<b>Service Note</b>		
Product	Description:	Service note no.
<b>Impact Twin</b>	<b>Analog audio mutes</b>	<b>SNo-T0181</b>

Product	Description:	Service note no.
Impact Twin	Analog audio mutes	SNo-T0181

C315, C316, C317 and C318

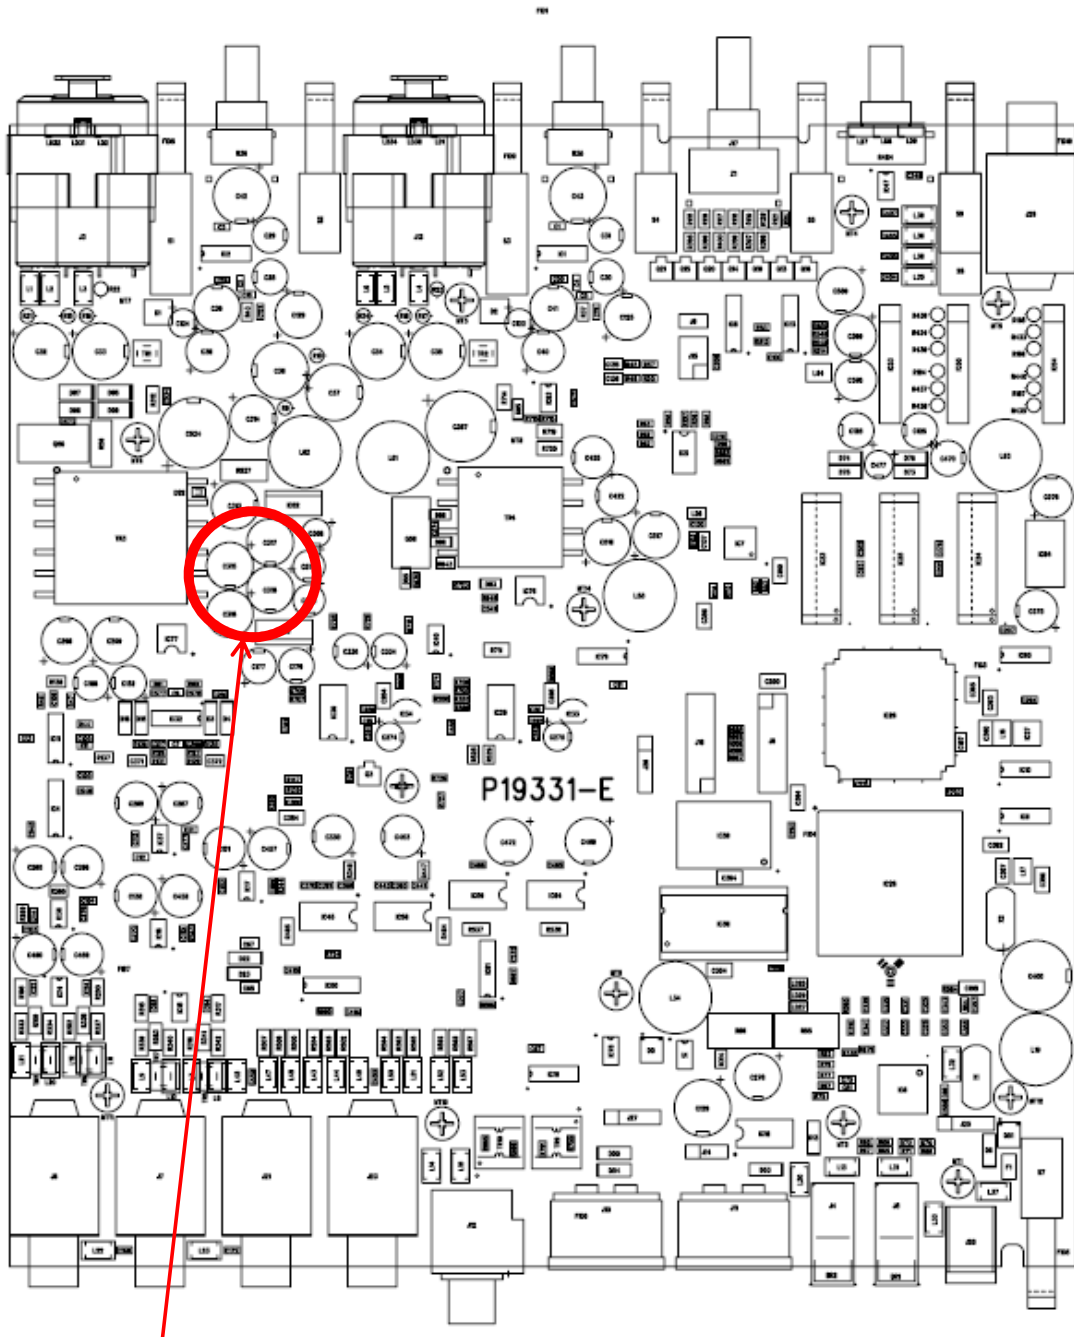
We have seen cases where the product, if exposed to extensive heat or situated in an heated environment, mutes the audio permanently.

The incidents we have analyzed are caused by the analog 12 volt which has dropped down to some 8 volt followed by triggering of the mute circuit.

Our investigations show that it is caused by degrading of C315, C316, C317 and C318 if these are Hitano types.

If C315, C316, C317 and C318 are Hitano types it is our recommendation that these are replaced. However if the Impact Twin is within the warranty period these must be replaced.

A package of 4 capacitors for replacement has TC stock no 7E22301699
